DATE: May 20, 2024
TO: Mandy Cole, Chair, Planning Commission
BY: David Matthew Peterson, Planner II *David Peterson*
THROUGH: Jill Lawhorne, Director, AICP

PROPOSAL: Applicant requests a preliminary plat review for a subdivision that will result in ten (10) lots. The lots will consist of three (3) panhandle lots and one (1) private shared access serving four (4) lots. Additionally, Lots 9 & 10 may be further subdivided into private shared access subdivisions in the future.

STAFF RECOMMENDATION: Approval with conditions

To: Shawn Kantola
From: David Matthew Peterson, Planner II
Case Number: SMP2024-0002
Legal Description: Silver Acres Subdivision
Parcel No.: 4B2601020043

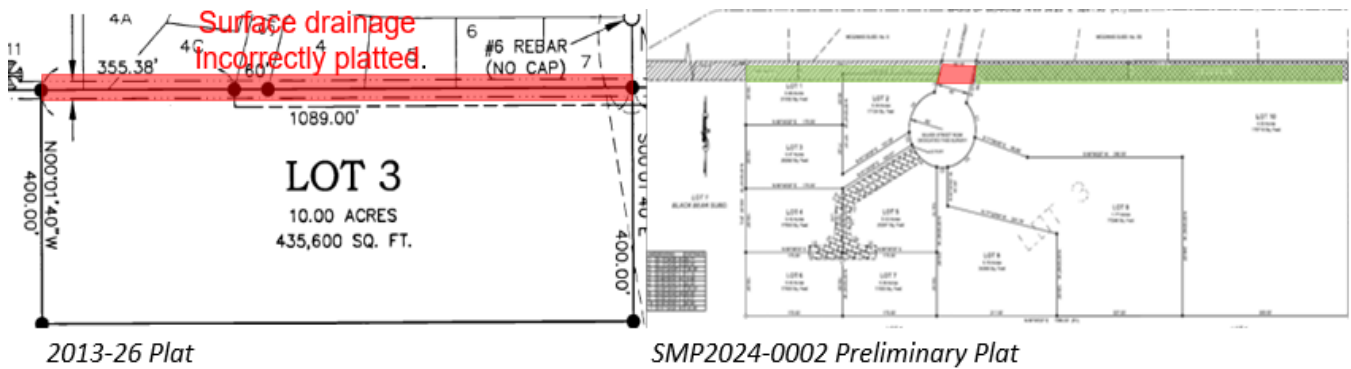
A surface drainage easement was incorrectly platted. Per Book 321 page 493 refers to the easement as being south of the common boundary. Plat 2013-26 shows it as straddling the property line, in error (image below, left). However, property owners did not authorize the easement (Lots 4A, 4C, 4, 5, 6, and 7). On the submitted Preliminary Plat, the surface drainage easement has been relocated to be entirely on the Silver Acres Subdivision, while a portion that would otherwise go through the Silver Street ROW has been vacated.

NOTE 1: Developer will need to address how Lot 1 will maintain access through the surface drainage easement.

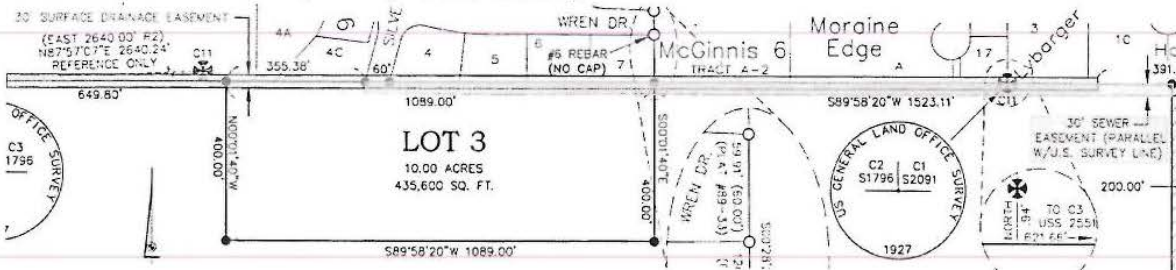
The Director is classifying this as a major subdivision as the endgame of the subdivision would be a potential phased development of 14 lots, or more depending on the future requirements of Division 2, 49.35.260 - Private Shared Access code.

NOTE: There is a Surface Drainage Easement that was incorrectly platted per Book 321 page 493 which refers to the easement as being south of the common boundary. Plat 2013-26 shows it straddling the property line, in error. Per plat 2013-26, a 30' surface drainage easement was recorded on the plat, but the property owners did not authorize the easement (Lots 4A, 4C, 4, 5, 6, and 7).

DRAWN BY: TSV DATE: 03/31/2024 SHEET: 1 OF 1

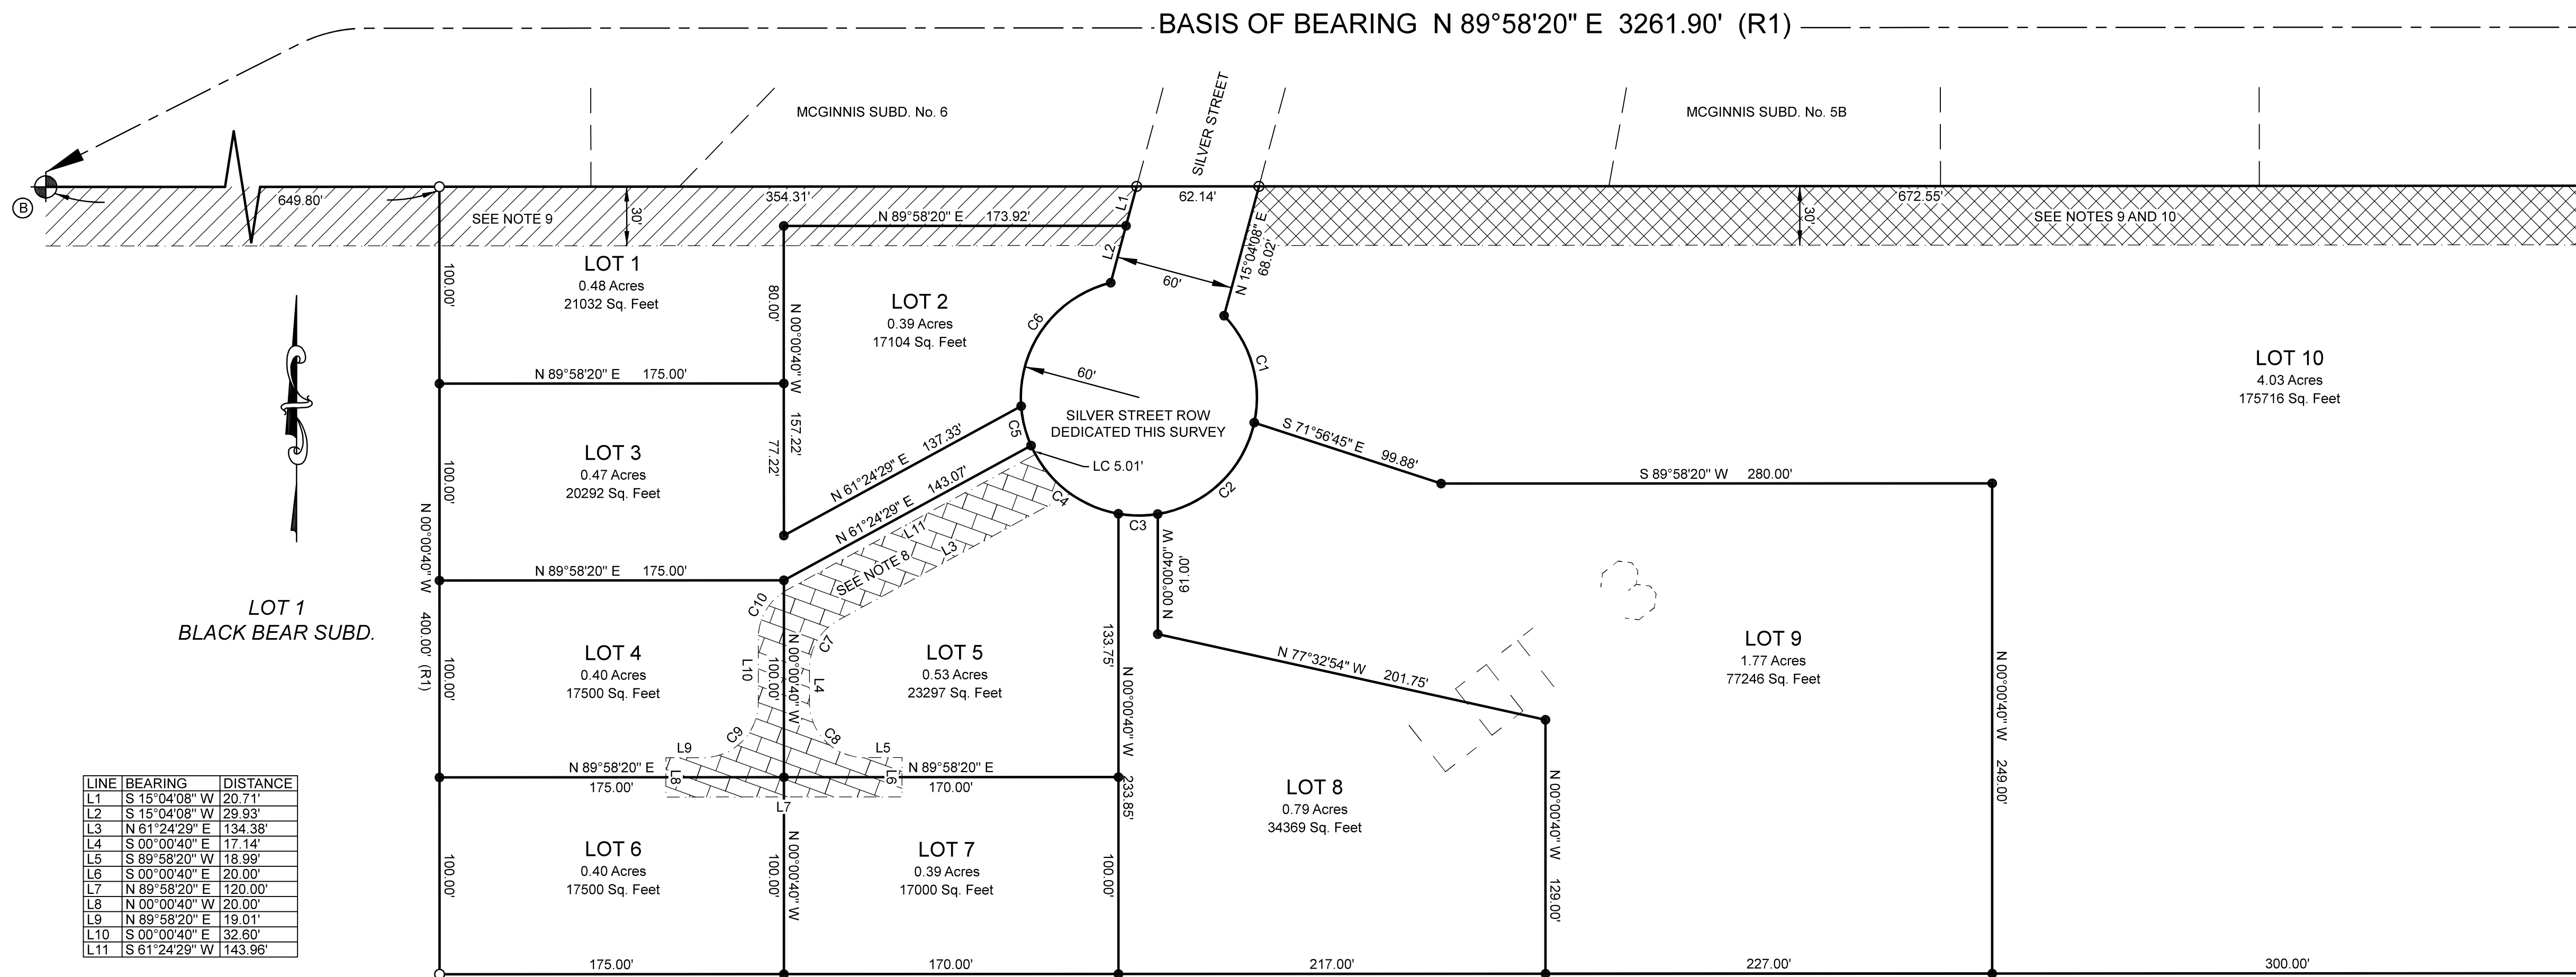
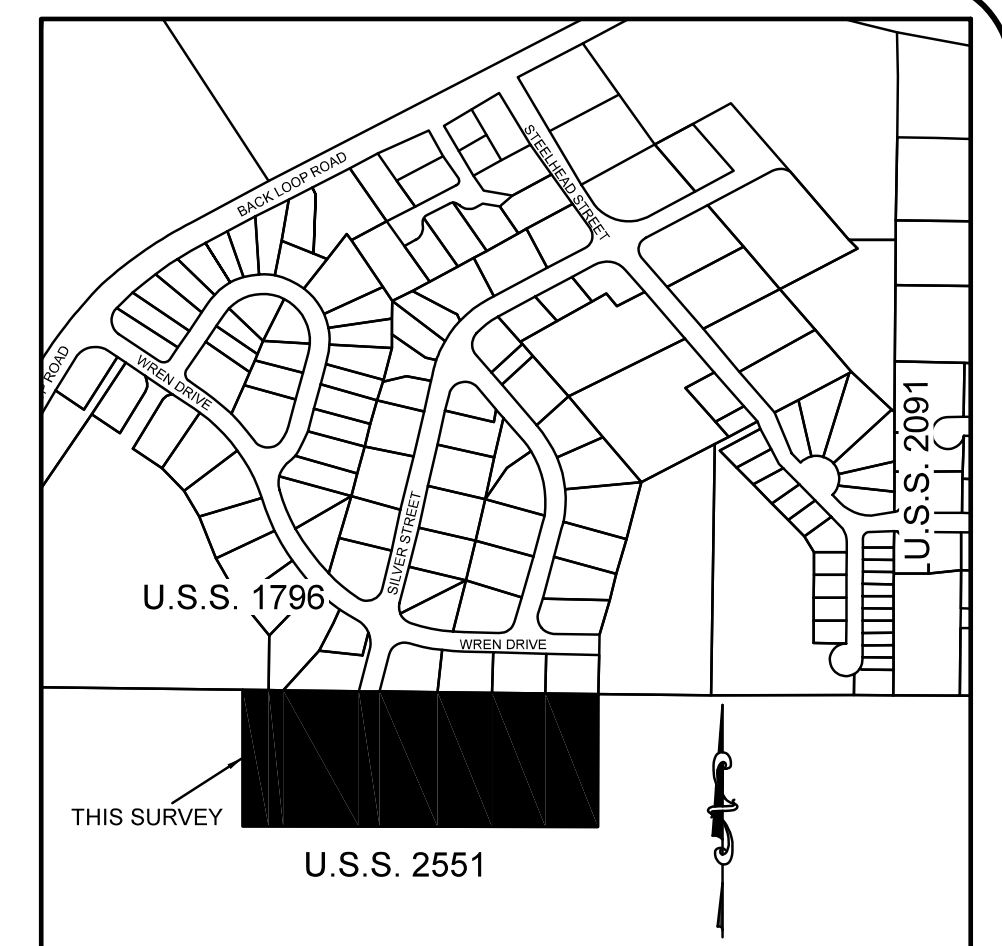
1. Label adjacent McGinnis Subdivision lots.
2. In the basis of bearing note, add “n” to “show”.

1. Include Private Shared Access dimension or note attesting to the PSA being 30 feet in width.
2. Update/Revise Closure Report bearings or provide clarification regarding discrepancies.
3. Revise Case Number to be: SMP2024-0002
4. Please include a fine dashed line to call out property setbacks. Reason being, Title 49 calls out that wherever two zones abut one another, the greater of the two setbacks will be applied to both lots.
5. Show CBJ trail in the drainage easement area.
